ADDENDUM TO THE BID DOCUMENTS		Page: 1	Total Pages: 3
<u>Addendum No:</u> # 1		<u>Date this Addendum Issued:</u> May 19, 2017	
<u>Issuing Office:</u> Matanuska-Susitna Borough School District (MSBSD) Purchasing Department 690 Cope Industrial Way Palmer, Alaska 99645 Phone: (907) 861-5120 Facsimile: (907) 861-5184		<u>Previous Addenda Issued:</u> None _____ _____ _____ _____	
<u>Return Acknowledgment To:</u> Issuing Department		<u>Date and Hour of Bid Due Date:</u> May 26, 2017 at 2:00 p.m.	
<u>Bid Title:</u> Big Lake Elementary School Water System Modifications		<u>As Advertised (Frontiersman):</u> May 7 and 10, 2017	
<u>Bid No:</u> B17-25		<u>As Advertised (ADN):</u> May 5 and 7, 2017	
<p>The following corrections, changes, additions, deletions, revisions, and/or clarifications are hereby made a part of the contract documents. In case of conflicts between this addendum and previously issued documents, this addendum shall take precedence. The bidder must acknowledge receipt of this addendum in the space provided on Appendix #1. Failure to do so may subject the bidder to disqualification.</p> <p>This addendum incorporates the attached 2 pages.</p> <p>Attachments:</p> <p>Clarificatio

DATE: FEB 2017
 STATUS: DRAFT
 SCALE:
 HORIZ SCALE: 1"=20'
 VERT SCALE: 1"=2'
 SHEET NO.
C2

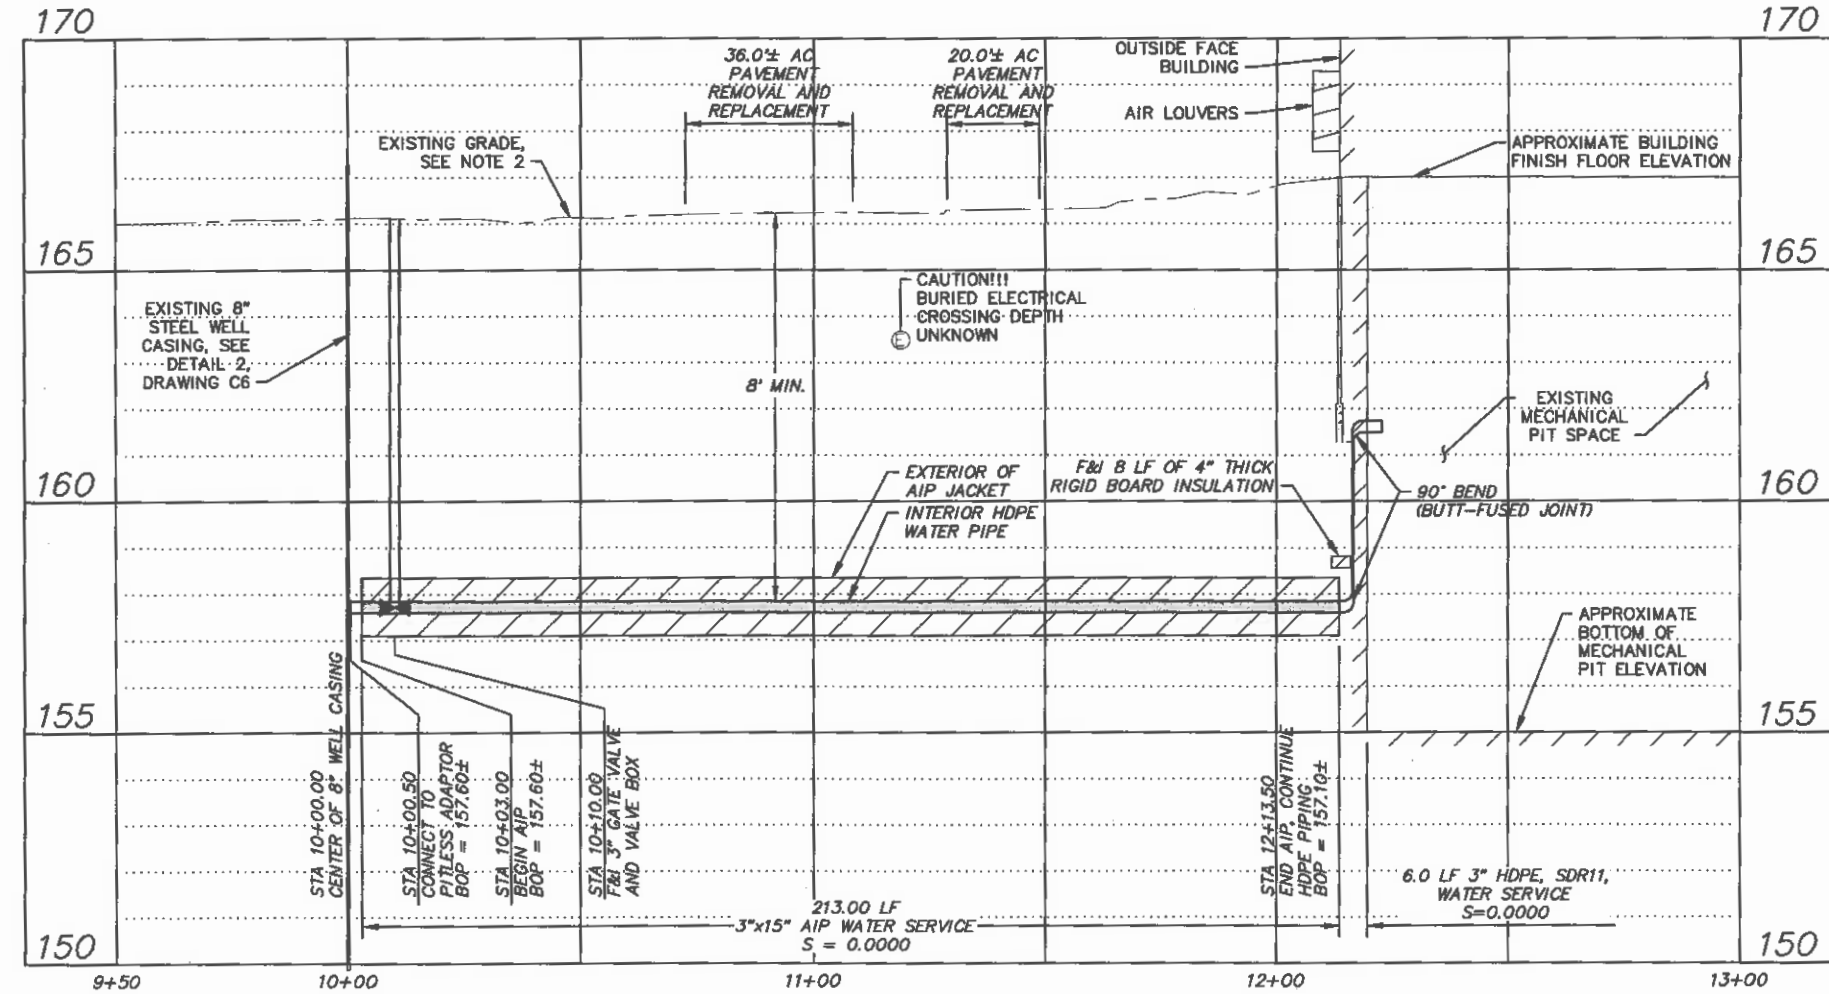
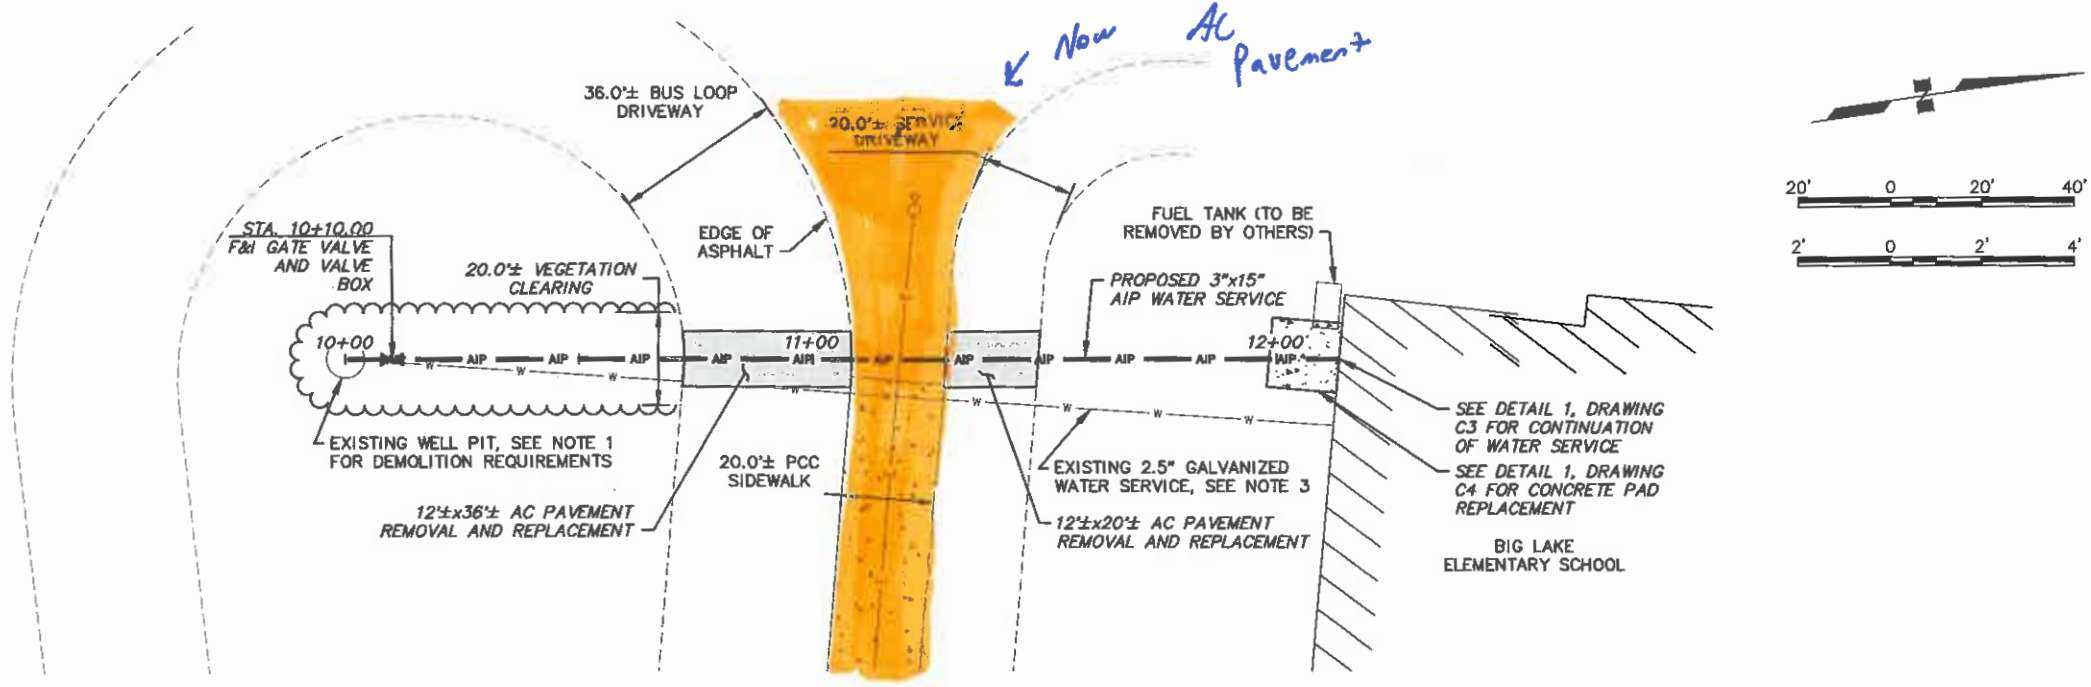
1. Q: Please clarify the surface composition of the area on the left of the School building. It is not shown as paved on the drawings.

A: The entire Bus Loop section is now paved. Paving extends across the entire driveway. See Appendix 8, Edited Drawing, Sheet C2 attached.
